GEN-2017-010 Modification Request Impact Study

Revision R1 October 8, 2024

Submitted to
Southwest Power Pool

Figure 2-2: GEN-2017-010 Single Line Diagram (Modification Configuration)

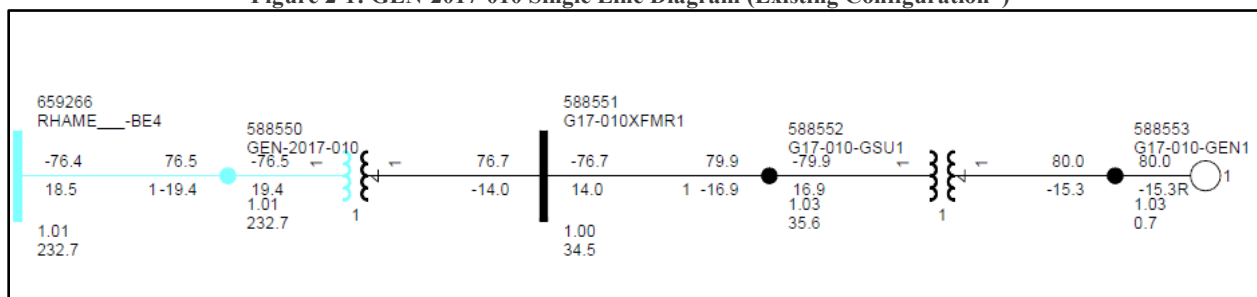
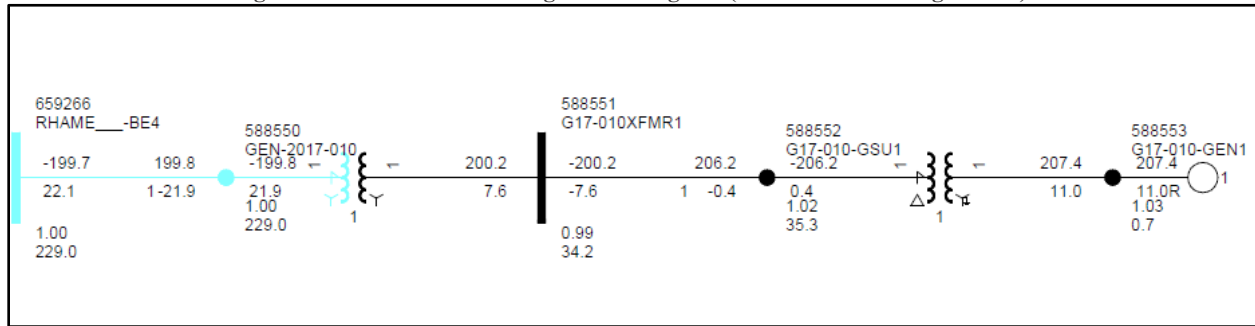
This Study has been requested to evaluate the modification of GEN-2017-010 to change the configuration to 74 x GE wind turbines operating at 2.8027 MW for a total assumed dispatch of 207.4 MW. The turbines are rated at 2.82 MW, and the generating capability (208.68 MW) exceeds its Generator Interconnection Agreement (GIA) Interconnection Service amount. The injection amount must be limited to 200.1 MW at the POI as listed in Appendix A of the GIA. As a result, the customer must ensure that the amount of power injected at the POI does not exceed the Interconnection Service amount listed in its GIA. The requested modification includes the use of a Power Plant Controller (PPC) to limit the total power injected into the POI.

In addition, the modification request included changes to the collection system, generator step-up transformers, main substation transformer, and generation interconnection line. Figure 2-2 shows the power flow model single line diagram for the GEN-2017-010 modification. The existing configuration from the DISIS-2018-002/2019-001 models and the modified configuration for GEN-2017-010 are shown in Table 2-1 below.

Figure 4-1: GEN-2017-010 Single Line Diagram (Shunt Sizes)

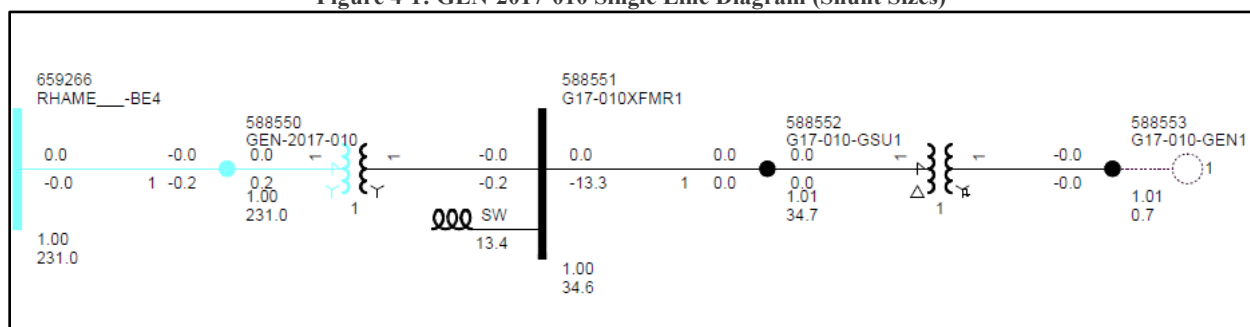
The results from the analysis showed that the GEN-2017-010 project needed approximately 13.3 MVAR of compensation at its collector substation to reduce the MVAR injection at the POI to zero. This is an increase from the 6.91 MVAR found in the DISIS-2017-001-2 study³. The final shunt reactor requirements are shown in Table 4-1. Figure 4-1 illustrates the shunt reactor size needed to reduce the POI MVAR to approximately zero with the updated topology.
